Service Bulletin #108

October 20, 1948

SUBJECT: MODEL PA-11 FRONT AND REAR SEATS

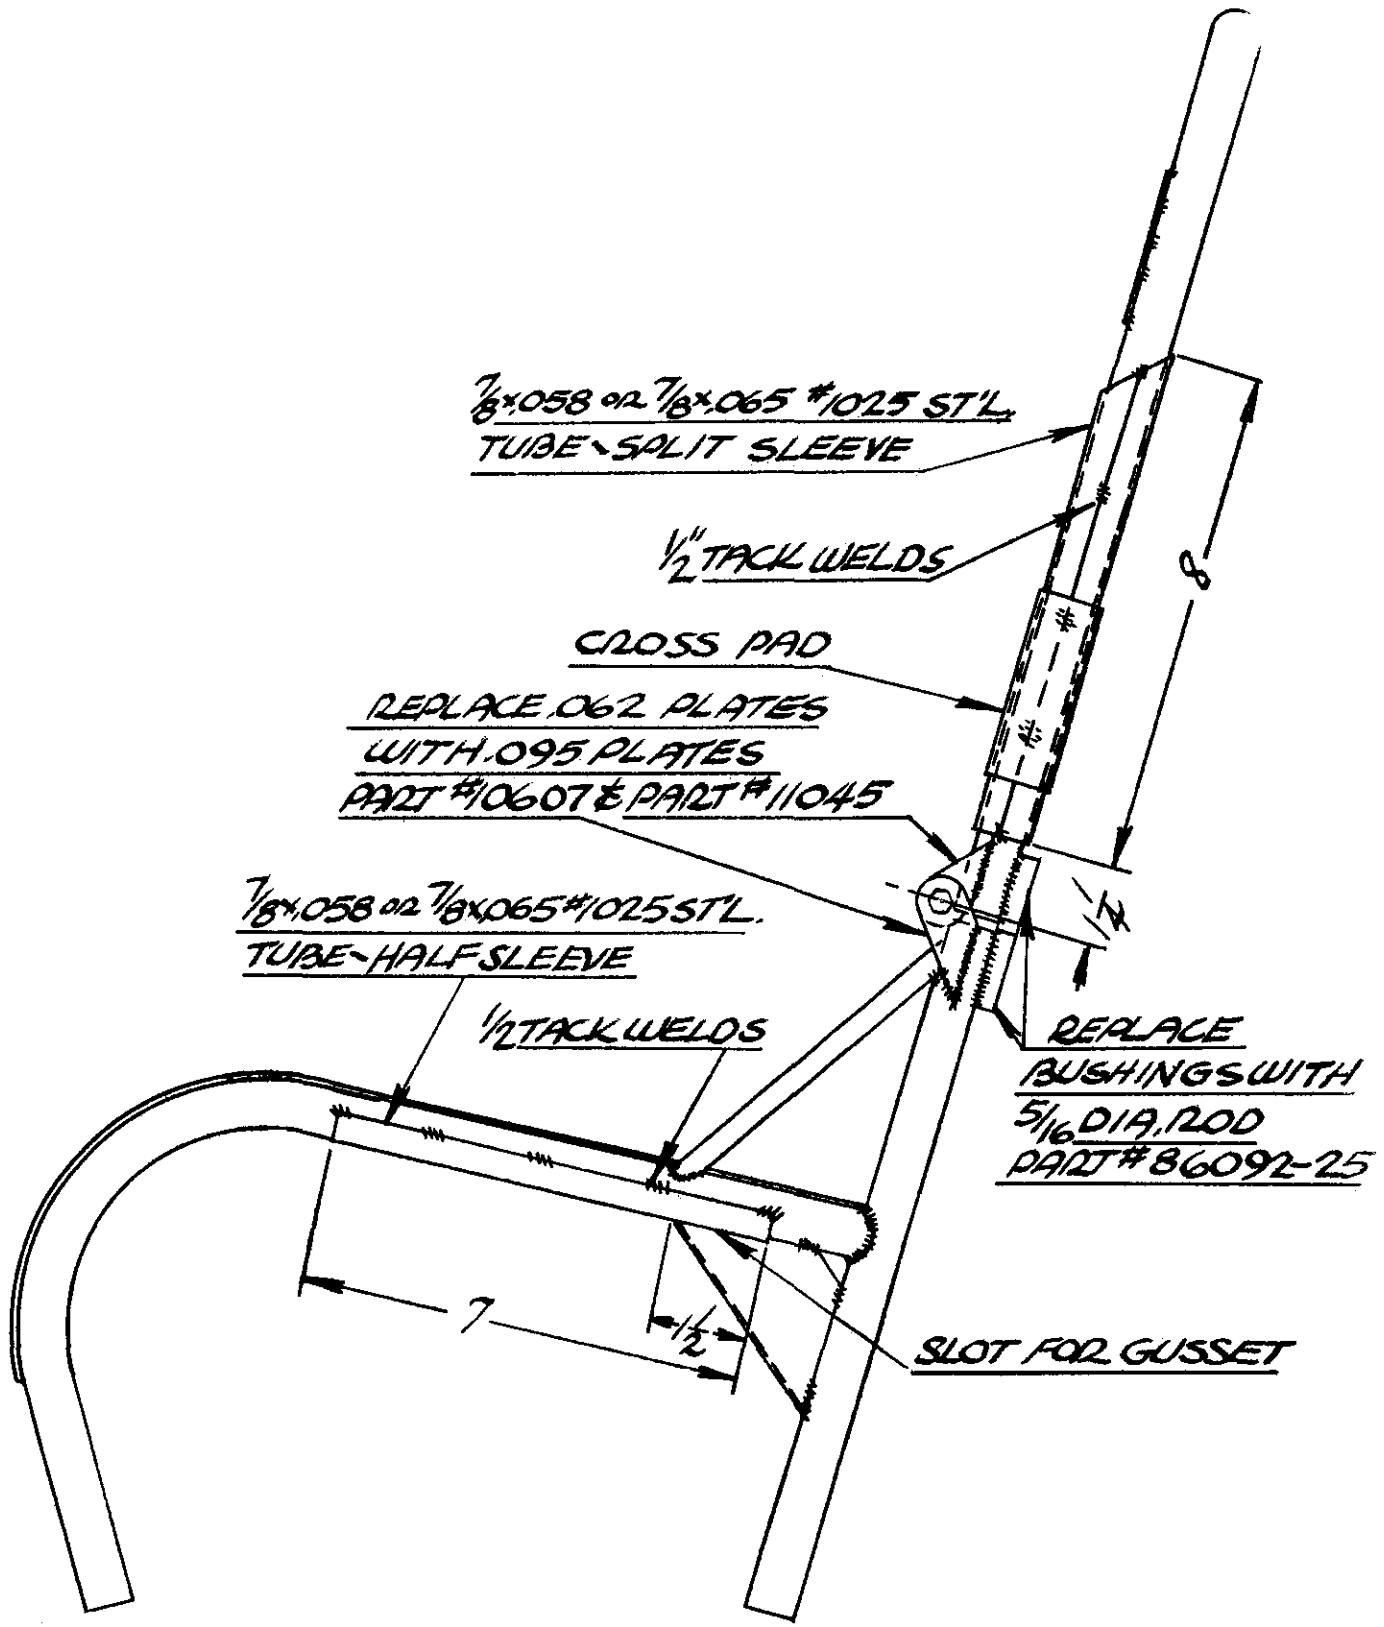
Failure of front and rear seat backs have been reported. These failures have been of a progressive nature and could be eliminated if proper maintenance and inspection are performed on the airplane.

The front seat has been bent backward resulting in bending of the seat side rail and back tubes, the crushing of the stop tubes at the hinges and the stretching of the hinge plate. In order to preclude the possibility of additional failures, it is recommended that the airplane be inspected and if such deformation is found, the following repairs may be made as needed or a new seat installed.

1. Side rail tube reinforcement

Add a half sleeve to underside of tube as shown on sketch.

2. Seat back tube reinforcement

Chip off lower sheet metal cross pad. Add split sleeve as shown on sketch and replace cross pad.

3. Hinge Revision

Replace present .062 hinge plates with .095 plates.

4. Stop Revision

Replace tube with cold rolled rod.

7/8 x .058 or 7/8 x .065 #1025 STL.
TUBE - SPLIT SLEEVE

REPLACE .062 PLATES
WITH .095 PLATES
PART #10607 & PART #11045

7/8 x .058 or 7/8 x .065 #1025 STL.
TUBE - HALF SLEEVE

REPLACE
BUSHINGS WITH
5/16 DIA. ROD
PART #86092-25
